Light Aircraft Association MANDATORY TECHNICAL DIRECTIVE

MTD-02-2026

Cracking in E-Props Carbon Propeller Hubs

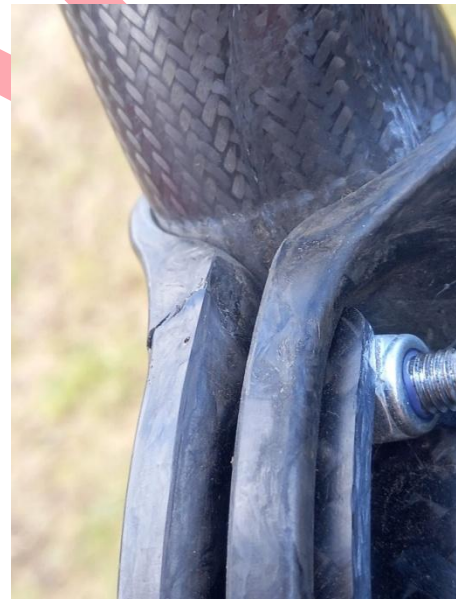
A 2025 report of a crack appearing on an E-Props carbon composite propeller hub was received by the British Microlight Aircraft Association (BMAA), as shown in the photos below. The crack was in the flange forming the periphery of the circular hub, in the close vicinity of one of the bolts in the outer ring of blade clamping bolts.

Given the implications of reduced clamping force and blade security for flight, this MTD is raised to mandate the removal of cracked E-Props carbon (CFRP) hubs from service.

Required Action(s)	<p>Operators of aircraft fitted with E-Props carbon (CFRP) hubs must:</p> <ol style="list-style-type: none"> 1. Inspect the propeller hub, removing the spinner as necessary, to check for any signs of cracking, paying special attention to the flange forming the periphery of the circular hub and the vicinity of any bolts. 2. If any cracks are detected, before further flight, the hub must be replaced with a serviceable, uncracked hub or the propeller replaced with an alternative propeller approved for that aircraft. <p>Repeat action:</p> <ol style="list-style-type: none"> 3. The inspection in Step 1 must be repeated at intervals not exceeding one calendar year. 		
Compliance Time(s)	<p>Initial Compliance Initial inspection of the hub to be carried out within the next 5 flying hours from the effective date of this MTD.</p> <p>Repeated Compliance The inspection in Step 1 must be repeated at intervals not exceeding one calendar year.</p>
